PREVOST

WARRANTY BULLETIN

WB13-56

DATE :	SEPTEMBER 2013	SECTION :	12 - Brakes
EXPIRATION:	SEPTEMBER 2015		
SUBJECT :	AIR LEAK ON AIR DRYER PROBE

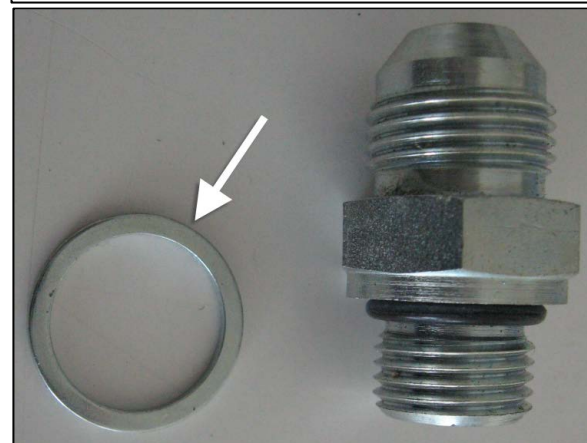
4. Disconnect and unscrew the probe, leaving the fitting on the air dryer (unscrew only the probe).

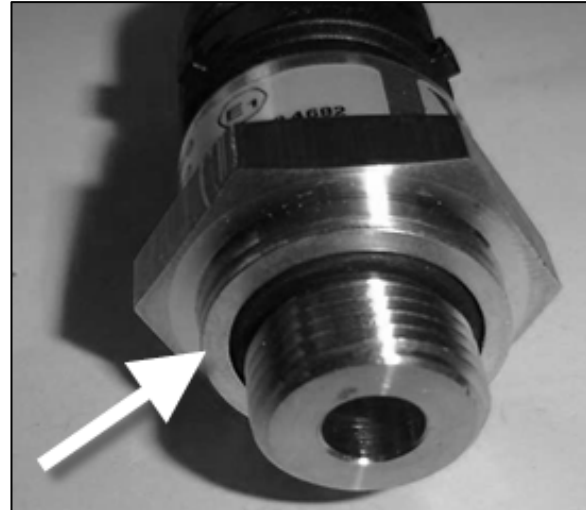
On the vehicles affected by this bulletin, the air dryer assembly may present a leak at the pressure probe connection. The O-ring in this location may be deformed due to the fitting arrangement. Adding a metal ring will prevent this issue.

5. If you have fitting 641294, take this ring to install on the probe.

6. Add ring 504789 at arrow location and re-install probe on air dryer assembly.
